SAFETY RECALL

Communication #: I-22-04

SUBJECT: FTR COOLANT JUNCTION

Indian Motorcycle has determined that Model Year 2019-2020 and 2022 FTR motorcycles may experience a failure at the coolant junction resulting in coolant loss during operation. If this occurs, coolant may come in contact with the rider, posing an injury hazard and/or coolant may come in contact with the rear tire, posing a crash hazard.

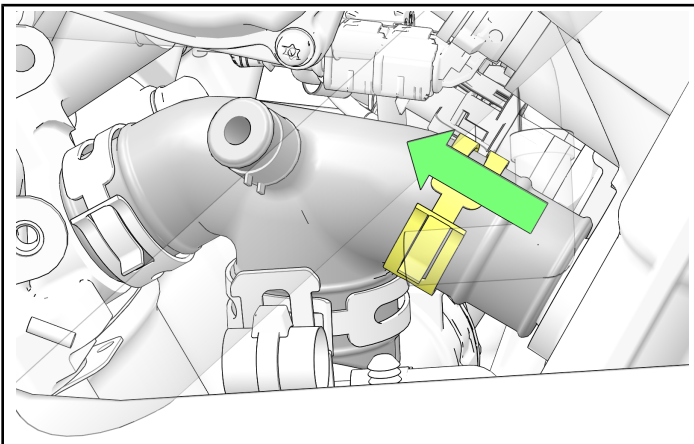
1. Release the clamp and then remove coolant bleed fitting ⑦ from the coolant junction.

2. Remove the coolant junction using the sequence of steps below for best removal procedure.

- a. Slide the **REAR** clamp up as far as possible.

- b. Install a remote clamp tool on the **FRONT** and leave it attached to the clamp.

- c. Using a 90 degree needle nose pliers, insert through the left-hand frame, squeeze the bottom clamp to release, and lift the coolant junction up and out.

3. Remove and retain the clamps for use with new coolant junction.

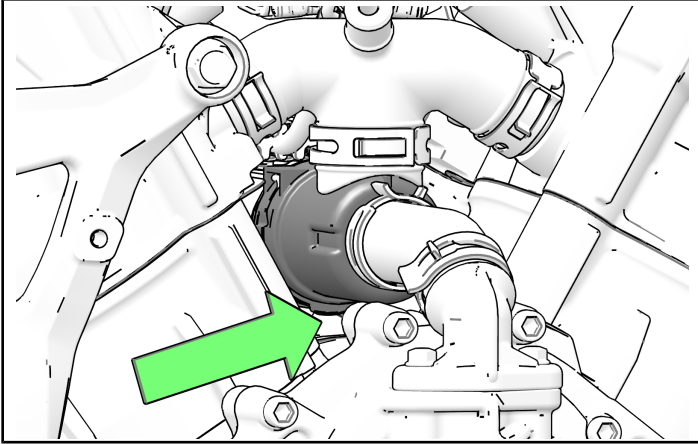
Verify new 5418558 coolant junction is being installed by checking the part number molded into the coolant junction.

4. Preset the REAR clamp on the coolant junction. The springband clamp should be positioned above the rib on the coolant junction.

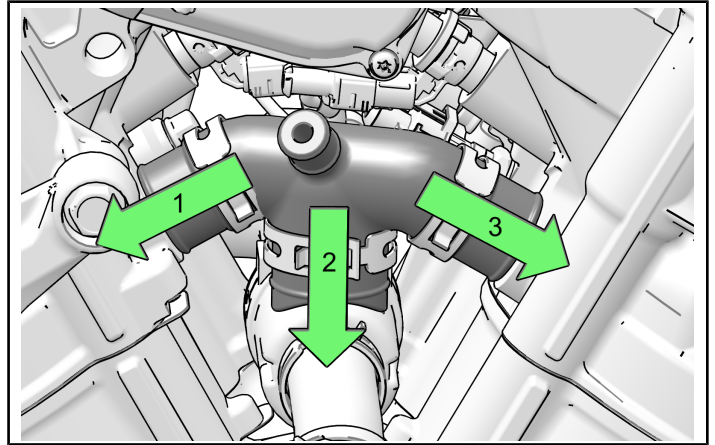
7. Make sure you align the NEW coolant junction notch with the thermostat alignment tab.

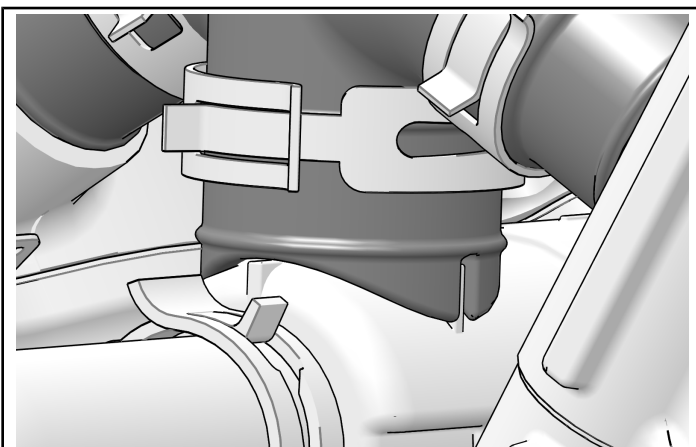
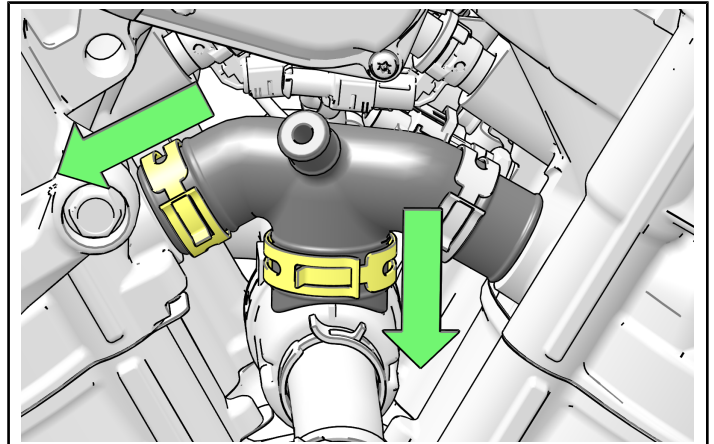
9. Verify the coolant junction is fully seated by ensuring the ends of the coolant junction are in contact with the cylinder and thermostat and no part of the fitting is showing:

- Verify the FRONT of coolant junction is fully seated.

- Verify the REAR of coolant junction is fully seated.

- Verify the BOTTOM of coolant junction is fully seated.

If not properly seated, the coolant junction may leak.
